CITY OF CORCORAN
Corcoran Planning Commission Agenda
September 3, 2020 - 7:00 pm

RE: Nelson International Conditional Use Permit, Site Plan and Variance for the property at 10409 County Road 101 (PID 01-119-23-41-0001) (city file no. 20-022)

Subject: Nelson International – Plan Review Comments

1 East (Facing 101)
MC201 SCALE 1" = 10'-0"

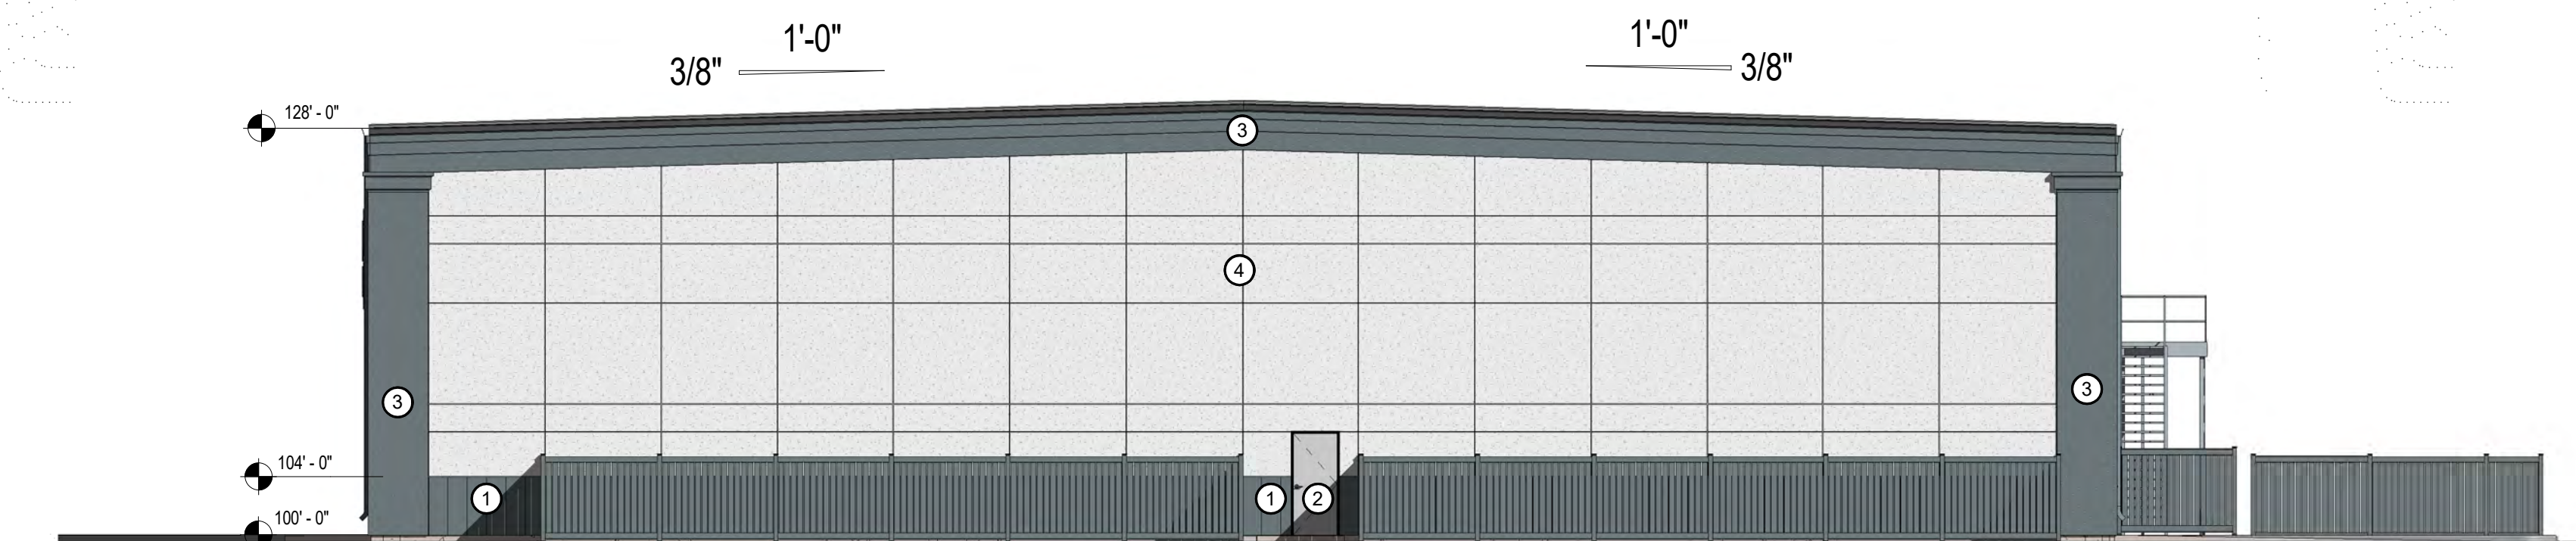
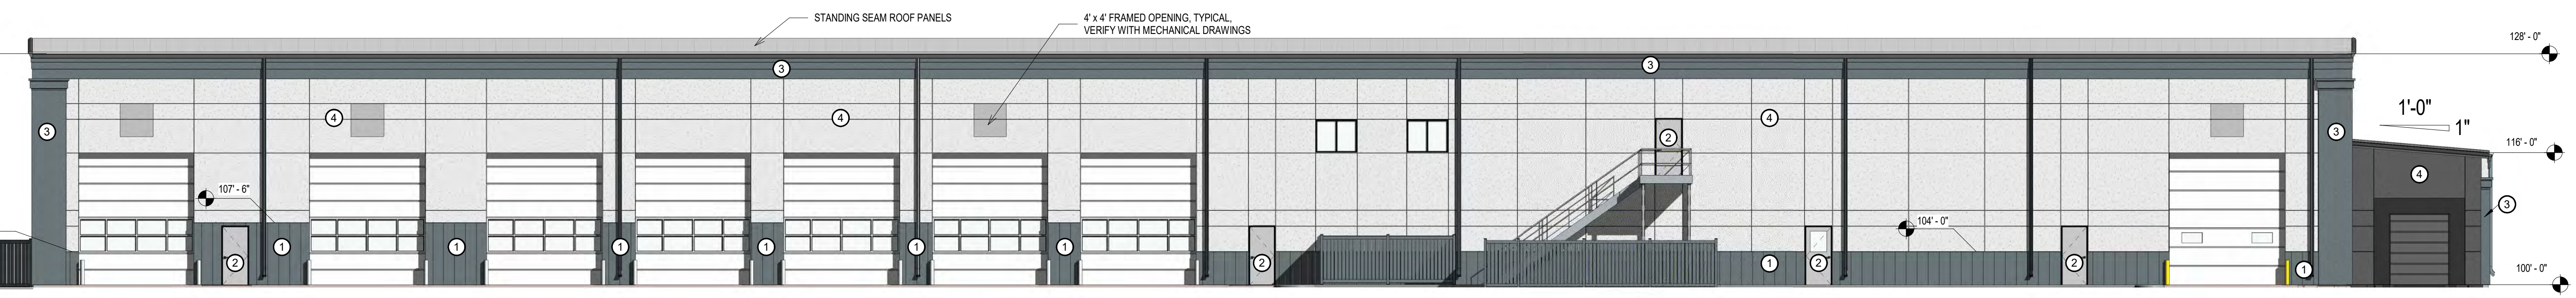
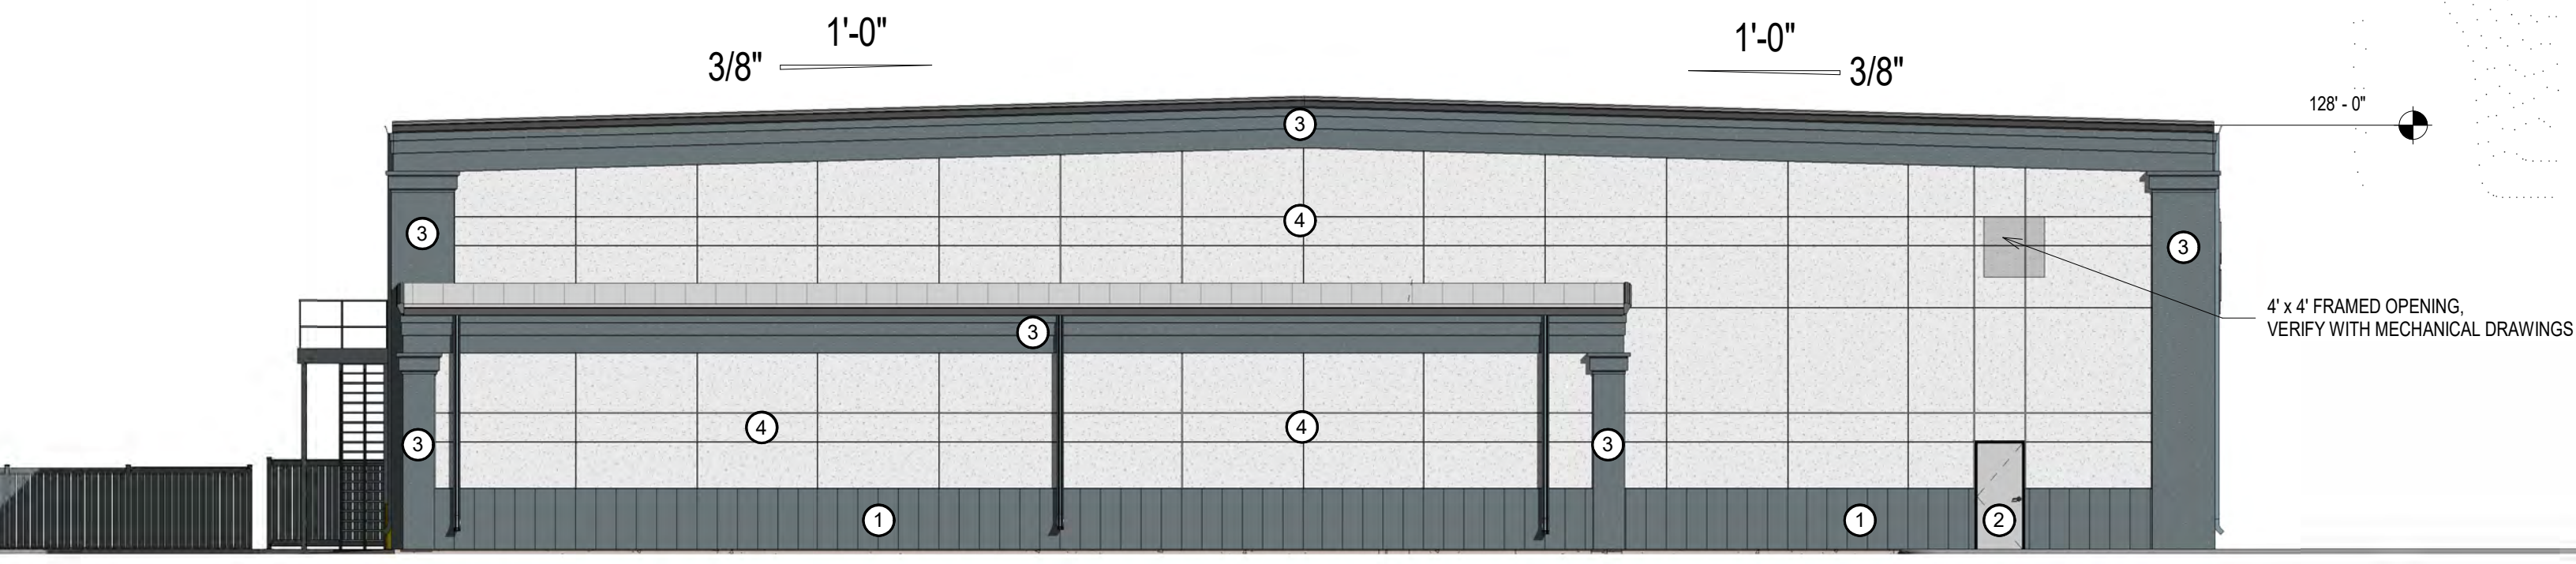
Architectural elevations were submitted showing a mix of glass, EIFS material and TextureClad, an architectural metal panel that is finished to look like stucco. The building is a rectangle with no articulation provided by physical changes to the building; however, the change in building materials does provide visual interest. The building materials have been revised to be in compliance with Section 1060.050 C(1) and the building now has two colors. Staff believes the current design of the building meets the intent of the design guidelines.

whichever is less. The building is shown on the elevations to be 28 ft. Therefore, exterior lighting cannot be taller than 28 ft. Staff has included a condition that plans be revised to show compliance. This will require the lighting plan to be updated to reflect the lower pole height.

- b. The plans shall be revised to show lighting fixtures that are limited to be either 30 ft. or the roofline of the principal building, whichever is less.
